GS4GG Verification (Performance) Certification Report

VKU Certification Pvt. Ltd.

Project Title
West Bakr Wind Farm Project
Registry Project ID: 7739
Monitoring Period: 01/01/2023 – 31/12/2023 (both dates included)
For
First Climate Markets AG and Infinite Environmental Solutions Limited
VKU Project Reference No.
VKU.VER.24.24_GS_7739

Fig: Incorrect geocoordinate location of WTG 42

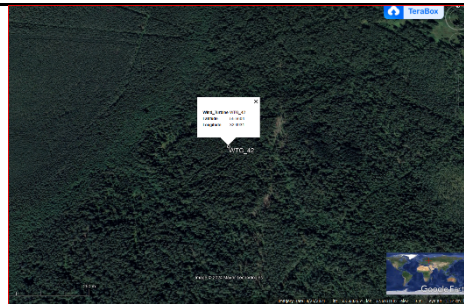
Since, 100% data was verified independently at site (substation metering point), the assessment team ascertains that the location of project mentioned is correct and in compliance with the registered PDD v6 /12/. There is one correction done in coordinate of WTG 42 which is assessed in the section 3.3 of this report. As per the registered PDD, geo-coordinate of WTG 42 was 480641 (Northing), 6157201 (Easting), which was found incorrect during desk verification

Type	Date	21-February-2024
CAR 03	Reference	Sheet A, C of Verification Protocol
Description of the Non-Conformance		
Section A.2 1. It is found that the coordinate for WTG_42 is not correct. Section C 2. PD has not provided the information of two lines of power evacuation. 3. It is found that in the line diagram below the voltage transformation from the WTG to the HV/MV transformers and to the grid is not mentioned or indicated. Section D.2 4. No data is provided to cross check the number of employees at site and the wages earned by them. Also, it is not clear as to how the wages provided are in line with the minimum wages act of Egyptian Govt norms.		
1 st Response from PP	Date	28-February-2024
Section A.2 1. The coordinate provided for the WTG -42 was incorrectly mentioned. The correct location has now been provided in the MR and the correction was mentioned in section B.2.2 of the MR. Section C 2. The information about the two lines of power evacuation has been mentioned in section C of the MR. 3. The wind turbine generator voltage level is 690VAC. The wind turbine generator nacelle is equipped with a dry type step-up transformer 0.69/33KV. The produced electricity from the wind turbine generators at the facility is collected via a medium voltage underground cable network at 33KV level from the wind turbine generators to the substation located medium

Fig: Corrected geo coordinate location of WTG 42 (480641 Easting, 3157201 Northing)

Verification team confirmed that correction done by the PP in latest updated MR for current monitoring period and the updated geo coordinate is correct as per the desk review with Google Earth Software application/33/.

1. It is found that the correct location for WTG-42 has now been provided in the revised MR section B.2.2. As per the assessment on Google Earth, the revised geocoordinate of WTG 42 is now so correct location. Hence, the finding is closed.

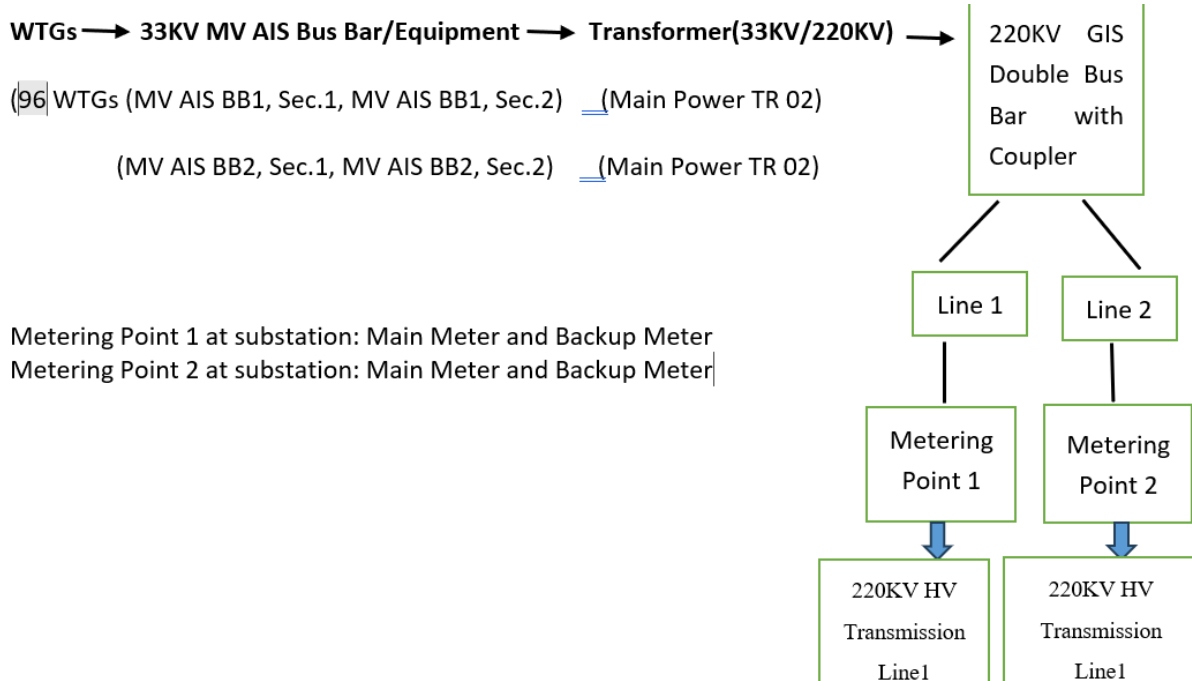
Verification Team confirmed that no WTGs are directly connected with the line 1 and line 2 as per the onsite inspection and submitted SLD diagram/18/. For understanding verification team provided the details of SLD in arrow manner below;

The wind turbine generator voltage level is 690VAC. The wind turbine generator nacelle is equipped with a dry type step-up transformer 0.69/33KV. The produced electricity from the wind turbine generators at the facility is collected via a medium voltage underground cable network at 33KV level

2. It is confirmed that the information regarding two lines of power evacuation has been mentioned in section C of revised MR. Hence, the finding is closed.
3. It is confirmed that the wind turbine generator voltage level is 690V AC. It is also confirmed that the produced electricity from the wind turbine generators at the facility is collected via a medium voltage underground cable network at 33KV level from the wind turbine generators to the substation located medium voltage collector/switchgear. PD has also updated the information in section C of MR. Hence, the finding is closed.
